ARKANSAS NUCLEAR ONE, UNIT NO. 1

AMENDMENT TO FACILITY OPERATING LICENSE

Amendment No. 37
License No. DPR-51

ATTACHMENT TO LICENSE AMENDMENT NO. 37

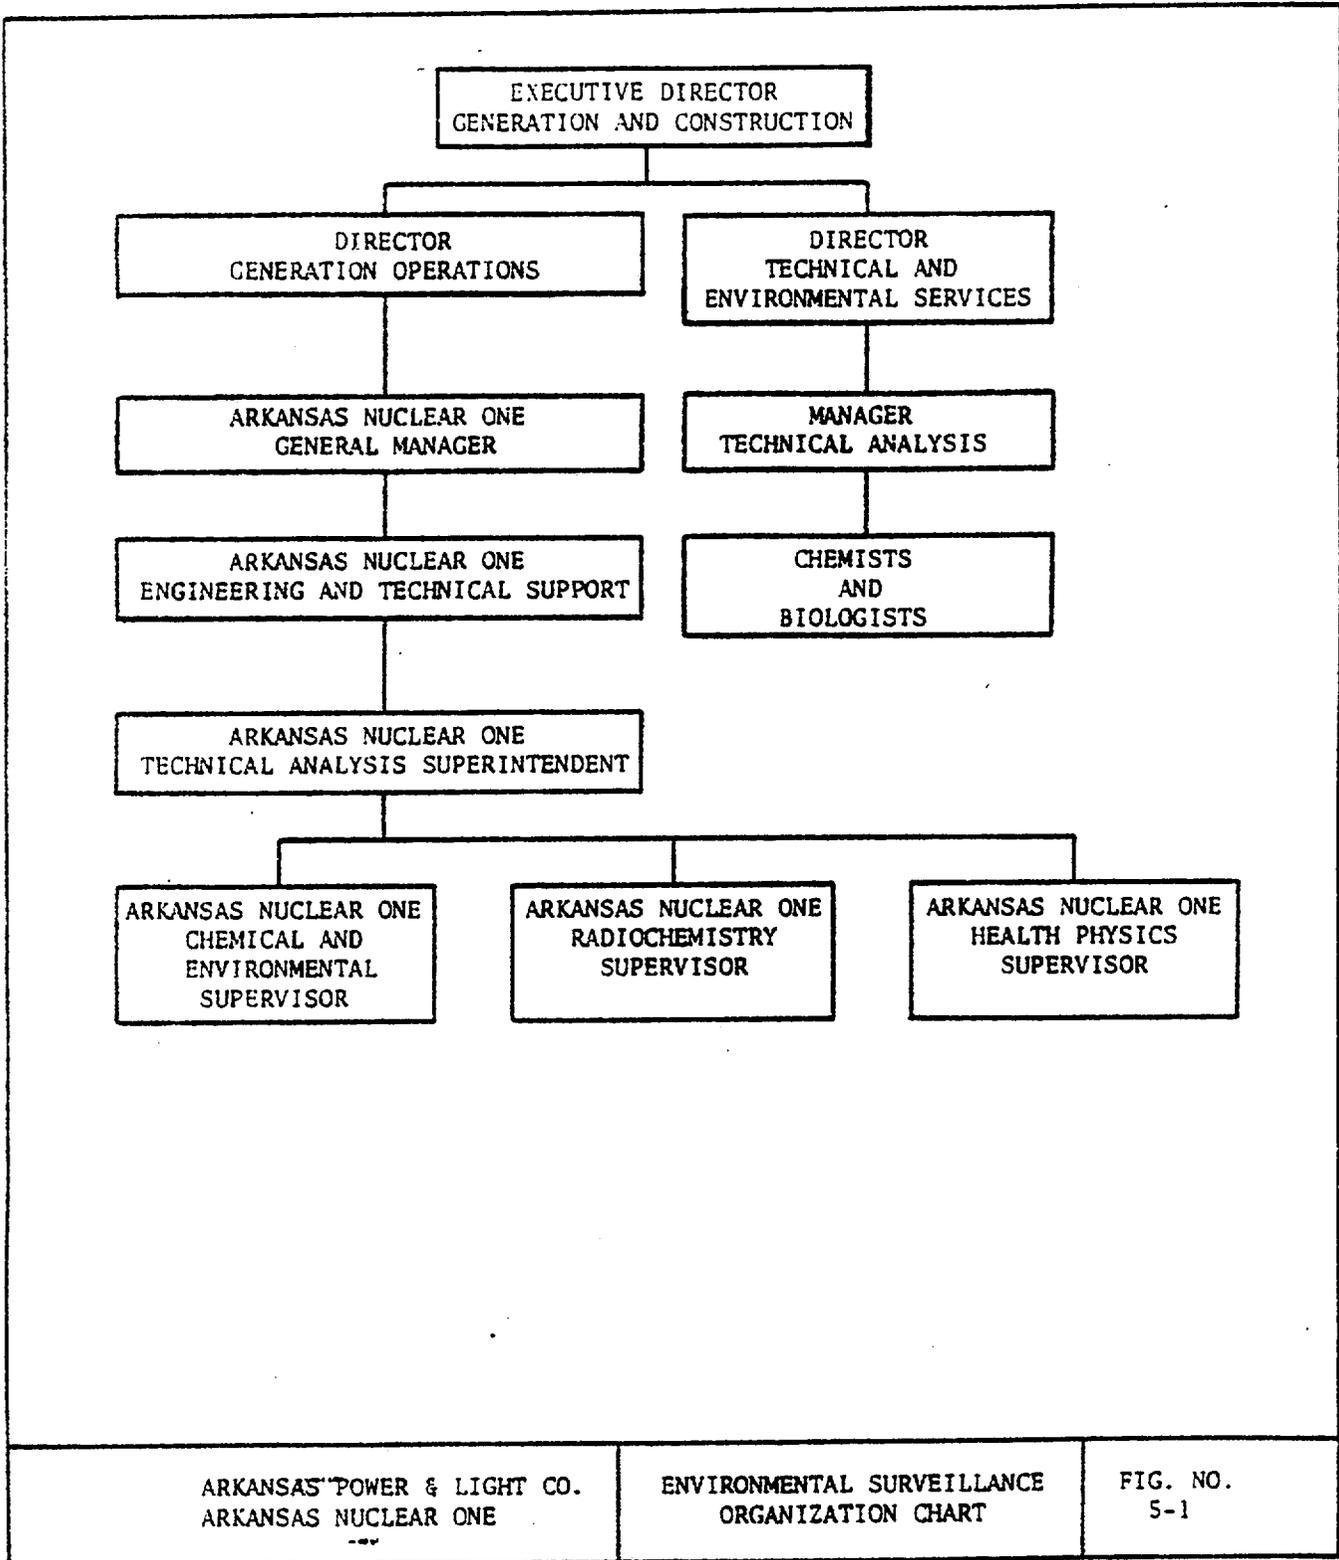
Figure 5-1 shows the organization chart at both plant and corporate levels relative to environmental matters.
